APPLICATION NO.	FILING DATE	FIRST NAMED INVENTOR	ATTORNEY DOCKET NO.	CONFIRMATION NO.
10/782,385	02/18/2004	Satoshi Mizutani	20050/0200895-US0	3573
7278	7590	12/07/2005		
DARBY & DARBY P.C. P. O. BOX 5257 NEW YORK, NY 10150-5257			EXAMINER BOGART, MICHAEL G	
			ART UNIT 3761	PAPER NUMBER
DATE MAILED: 12/07/2005

Office Action Summary	Application No. 10/782,385	Applicant(s) MIZUTANI ET AL.	
	Examiner Michael G. Bogart	Art Unit 3761

DETAILED ACTION

Fig. 1

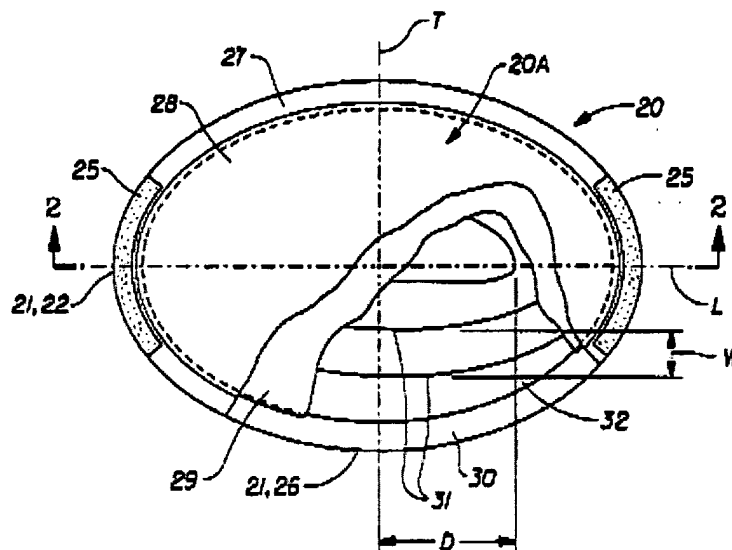
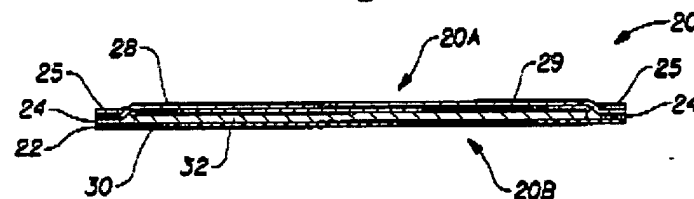
Regarding claim 1, Osborn teaches an interlabial pad (20) comprising:

an absorbent body (32) for absorbing liquid; and

a cover body (28, 30) covering the absorbent body (32) in an enclosing manner and comprising a surface side sheet (28) having a permeable property for liquid and a back face side sheet (30) having an impermeable property against liquid;

the interlabial pad (20) being fitted between labia with the surface side sheet set at a body side (28);

wherein the cover body (28, 30) is provided with a continuous or discontinuous parting zone (21, 24) that is parted by actions of water, along which the cover body is separated into a plurality of small sheet pieces (28)(30) when water acts (col. 2, line 41-col. 3, line 19; col. 16, line 45-col. 17, line 5)(see figures 1 & 2, below).

Regarding claim 2, Osborn teaches that the parting zone (21, 24) is provided in the back face side sheet (30).

Regarding claim 3, Osborn teaches that the parting zone (21, 24) is a seam part (21) formed by overlapping the plurality of small sheet pieces (28)(30) over one another.

Regarding claim 4, Osborn teaches that the plurality of small sheet pieces (28, 30) are adhered together at the seam part (21) by an adhesive agent (24).

Fig. 6

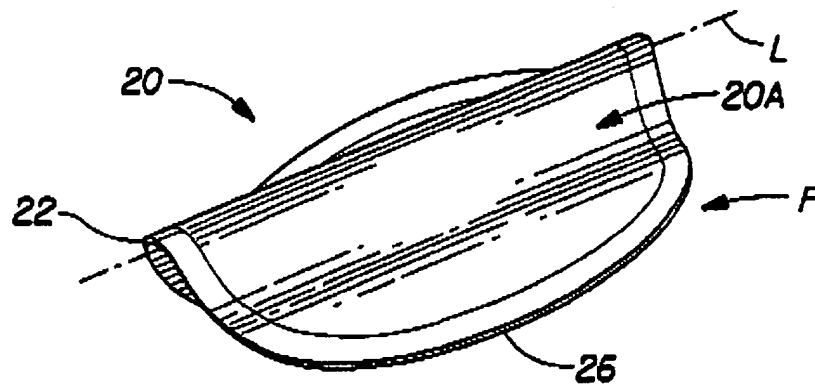
Regarding claim 9, Osborn teaches that the back face side sheet (3) is made uneven at least at the surface opposite (20B) to the absorbent body side (20A)(see figure 6).

Regarding claims 20-21, Osborn teaches that the back face side sheet (3) is made uneven at least at the surface opposite (20B) to the absorbent body side (20A)(see figure 6).

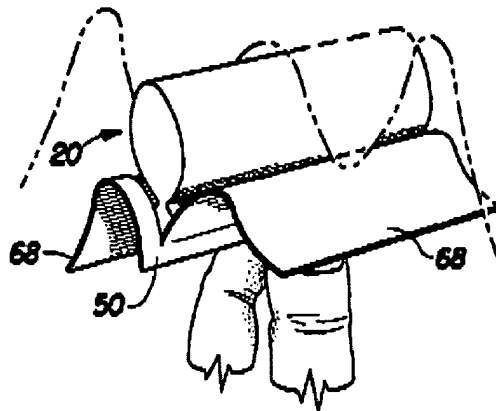
wherein the packaging sheet (68) is provided with a continuous or discontinuous parting zone that is parted by actions of water, along which the packaging sheet (68) is separated into a plurality of small sheet piece when water acts (page 19, line 20-page 21, line 23)(see fig. 5).

'573 teaches a interlabial pad (20) surrounded by a mini-sheet (68)(figure 5).

At the time of the invention, it would have been obvious to one of ordinary skill in the art to wrap the absorbent article of Osborn with the separable mini-sheet of '573 in order to provide packaging means (figure 5, below).
